Reelmaster® 2300 and 2600

Subject: Lift Arm has excessive fore and aft movement.

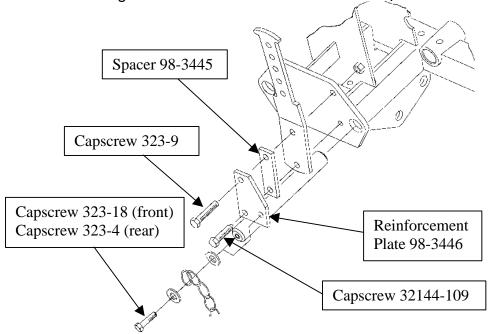
Some units may develop excessive wear at the lift arm pivot pin allowing excessive forward and rearward movement of the Lift Arms. If the lift arms become excessively loose, install the parts shown below to reinforce this area. Parts are available through your local Toro distributor.

3)	98-3446	Plate, Reinforcement
3)	98-3445	Spacer
3)	323-9	Screw
2)	323-18	Screw
1)	323-4	Screw
3)	32144-109	Screw

- 1. Raise cutting units and disconnect all counterbalance springs.
- 2. Lower cutting units to ground and remove ignition key.
- 3. Remove and discard three original fasteners shown below.
- 4. Install new fasteners through Reinforcement Plate and Spacer as illustrated. Note: Mount the short side of the reinforcement plate onto the pivot pin.
- 5. Raise cutting units and install counterbalance components.
